TAB Punch List CFA #05811 (Alliance FSU)

Prepared by Ben Searles

Sep 12, 2025

#92 [CNTL 016] [NEW] CRITICAL – Sensor communication.

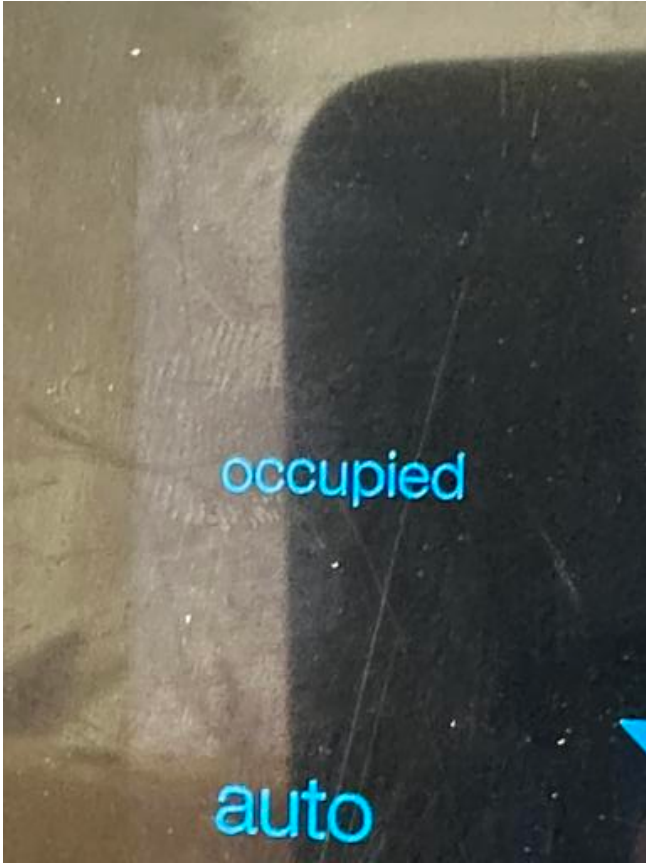
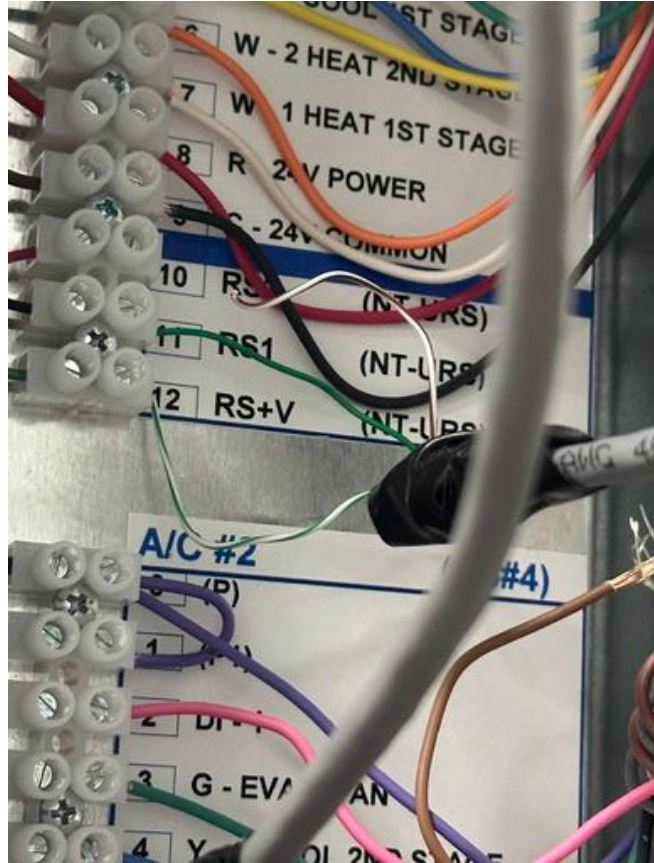
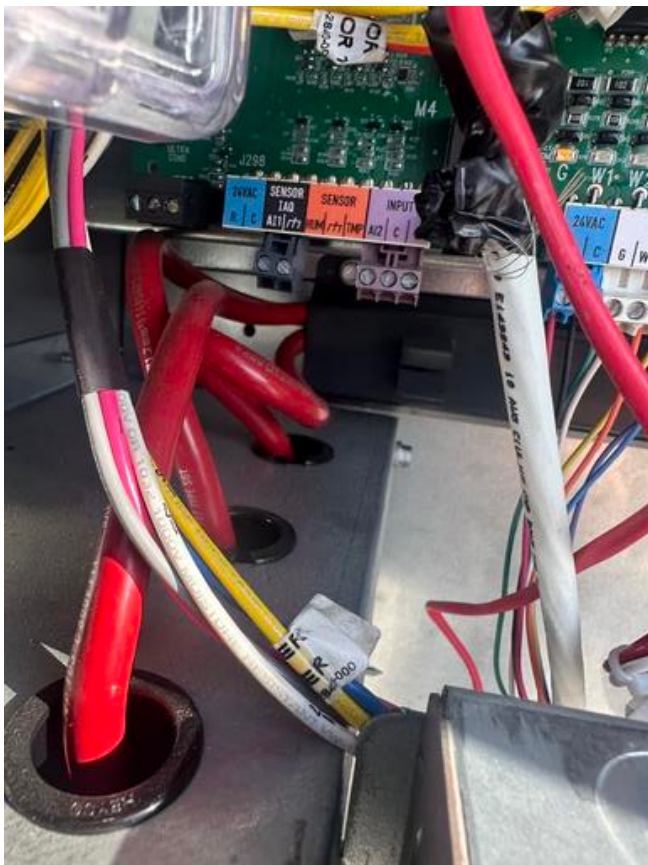
AC3's averaging sensors not communicating properly, check for correct terminations, correct dip switch / jumper settings, and shorts to ground. AC1's temp sensor has a loose wire at the terminal.

#91 [CNTL 499] [NEW] CRITICAL (MISC) – Humidity sensor wiring

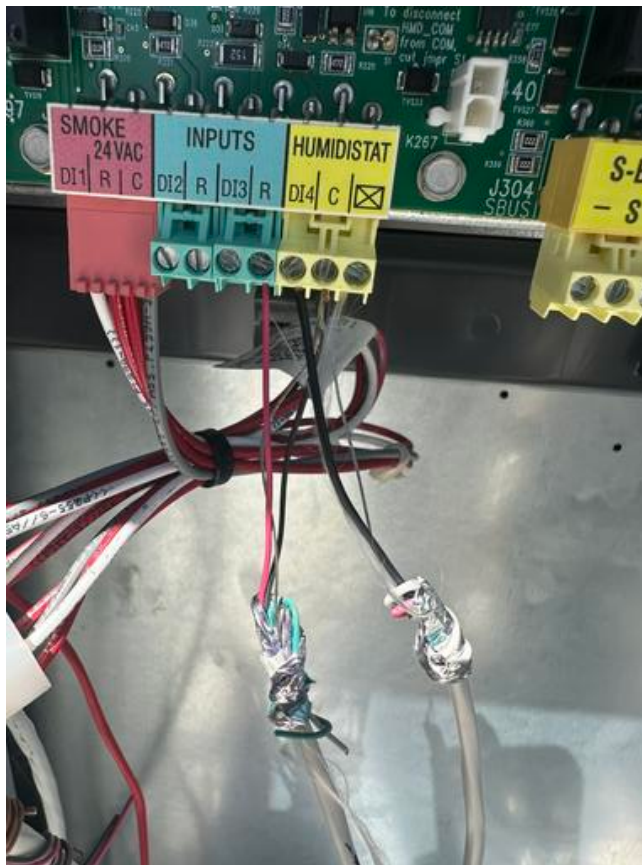
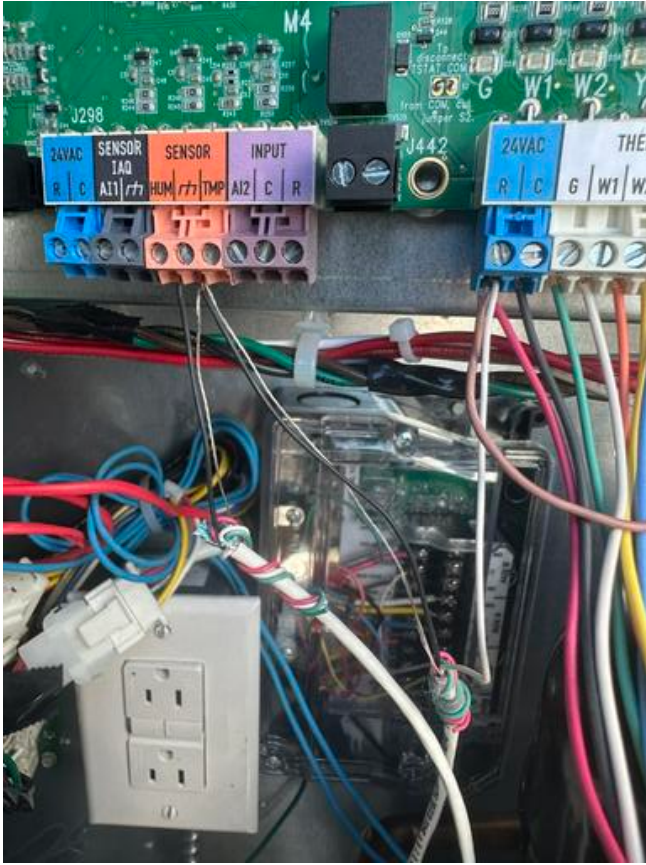
AC1 and AC3 are missing the correct ports to connect the humidity sensor wiring. All units are experiencing alarms regarding the sensor's wiring.

#90 [CNTL 506] [NEW] H.E.S. system

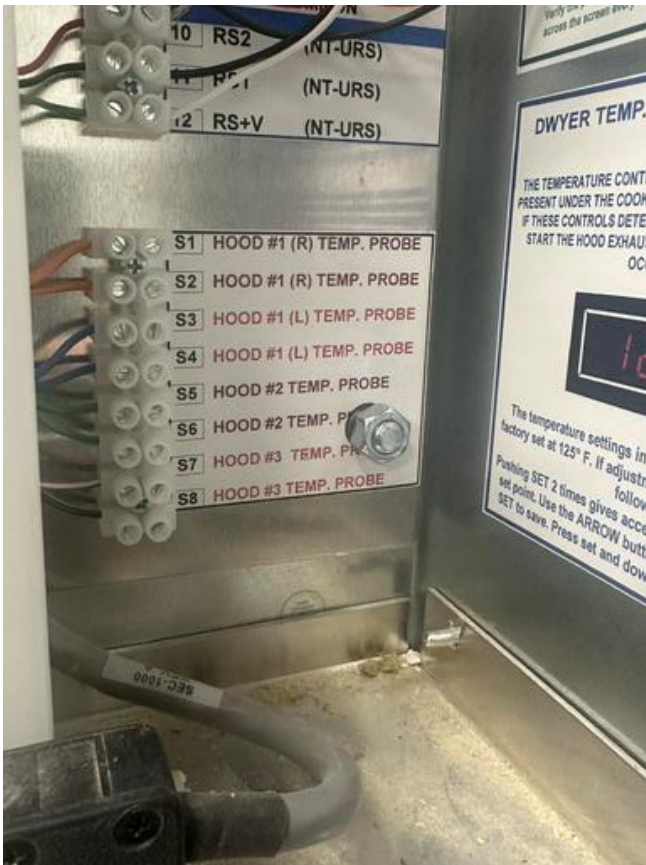
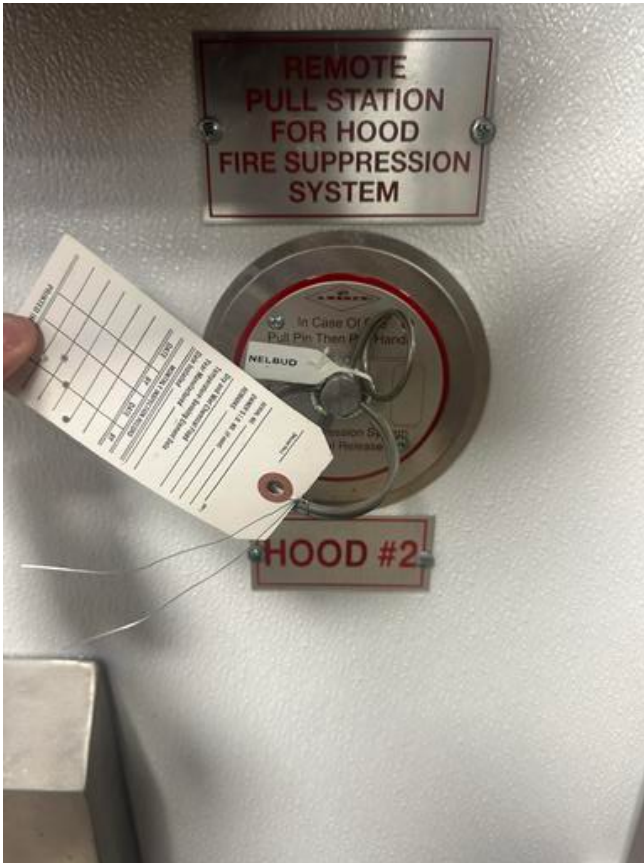
HESS sensors are not installed correctly in each hood duct riser and wires are not run to the panel.

#88 [CNTL 999] [NEW] (MISC) OCC/UNOCC RTU sequence.

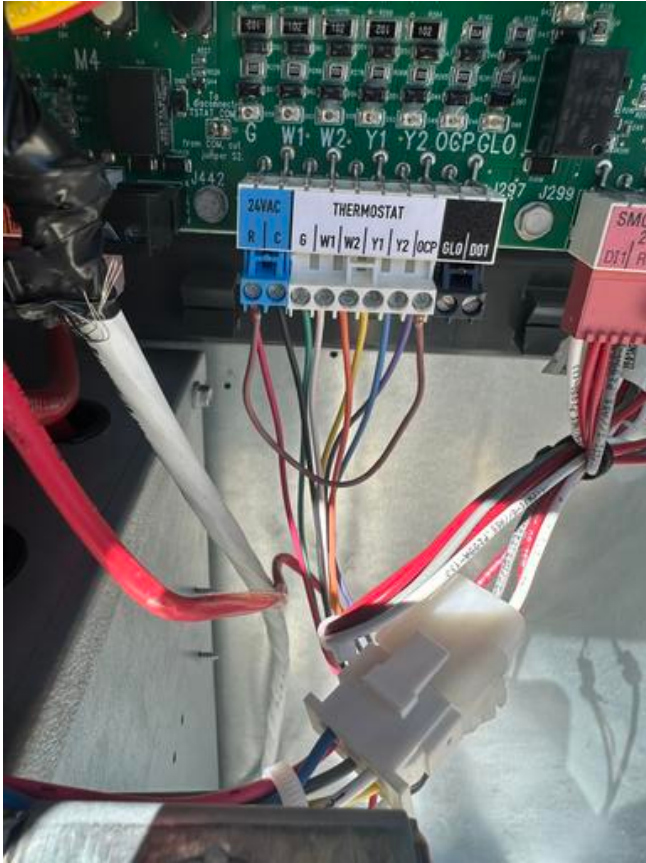
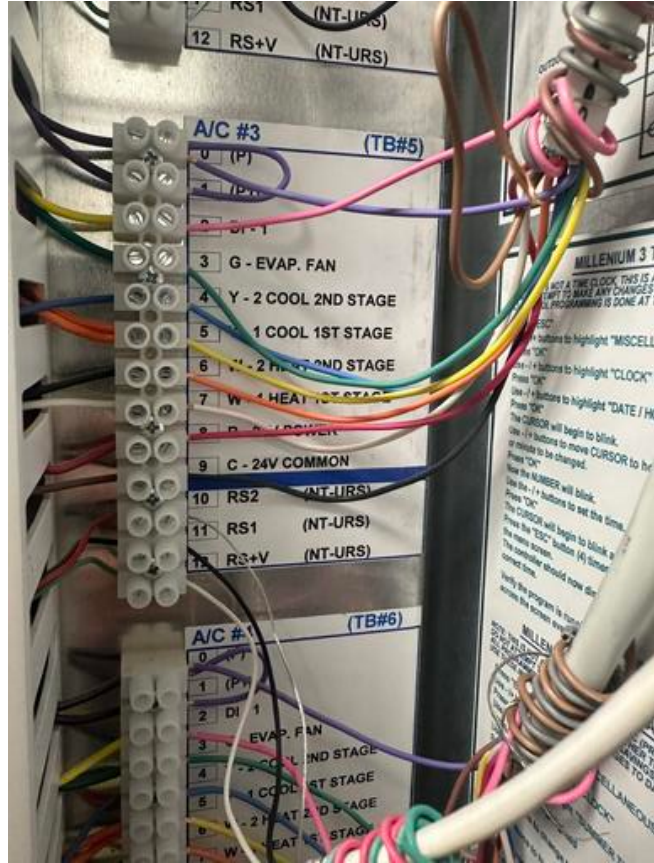
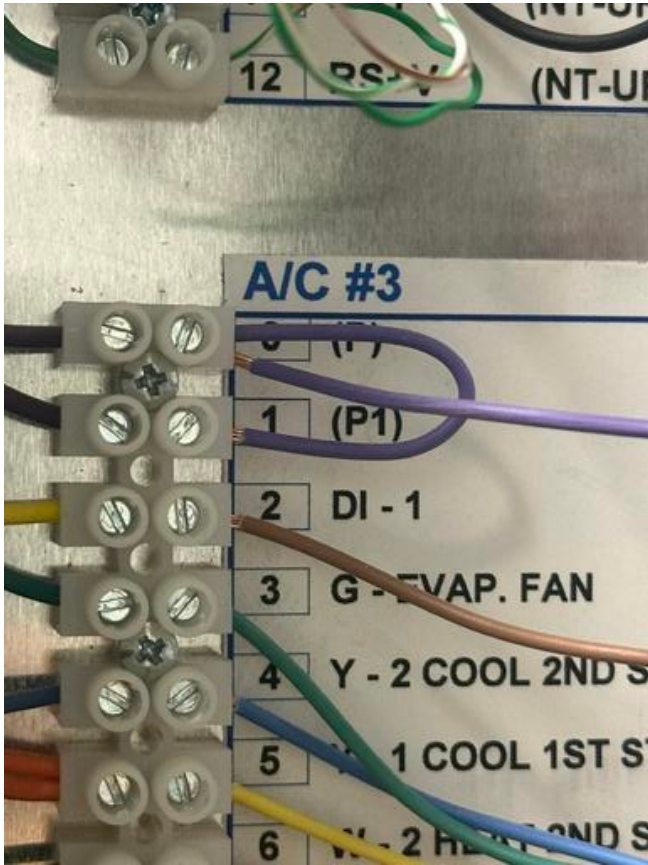
Store occupied / unoccupied switch does not properly alter RTU sequence. All units were jumpered from R to OCP. This wire needs to be removed and the wiring at the T-500 panel needs to be revised.

#81 [UNIT 501] [NEW] Equipment low voltage diagrams

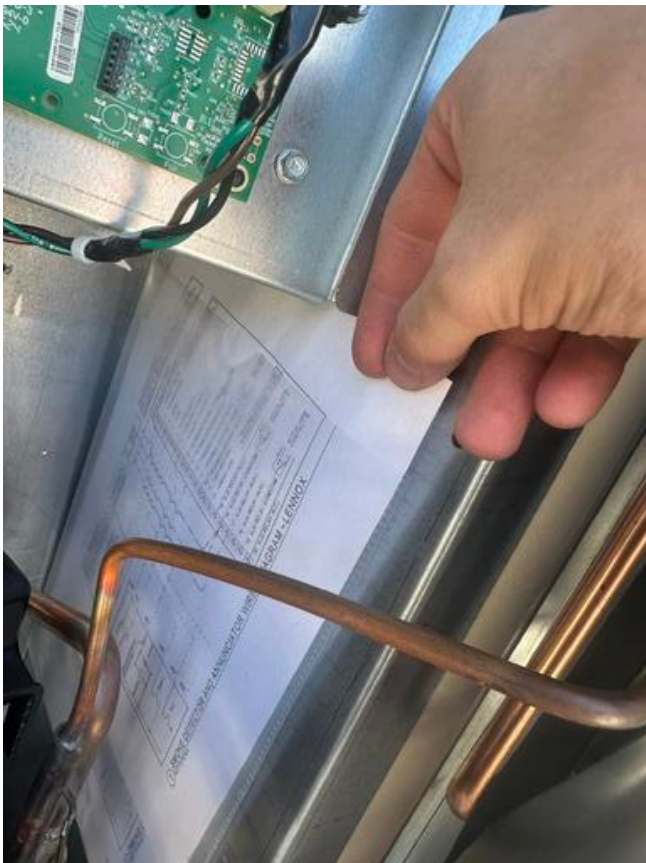
Equipment copy of controls detail low voltage wiring diagrams is not laminated.

Sheet
M-701L

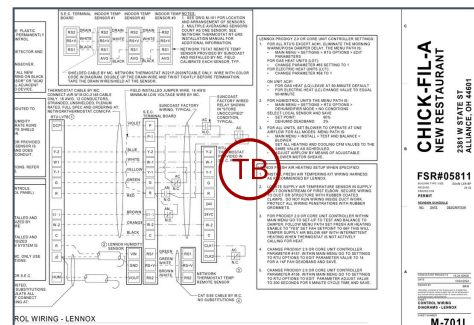
RTU Schedule indicates AC units are to have Fresh Air Tempering: Units with Fresh Air Tempering kits are to have the discharge sensor routed per specification into the discharge duct via wiring portal. The sensor should be installed after the first 90. For Lennox turn on FAH and set parameter #156 to 60 in Kitchen, 62 in Drive-Thru/Serving, & 63 in Dining/Play Area; then set parameters #157 to 14 & #158 to 300 on all.

See Notes on M-701L

Sheet
M-102L

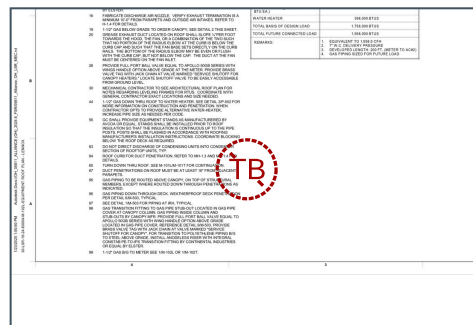
Key Note 87 on M-102L indicates all duct penetrations on the roof must be at least 18" from the parapet. EF-1 duct penetration does not comply. Recommend Review.

This duct is installed as per the design shown on sheet M-102L. If it needs to be moved, the drawings should be revisited so that required work can be priced and performed
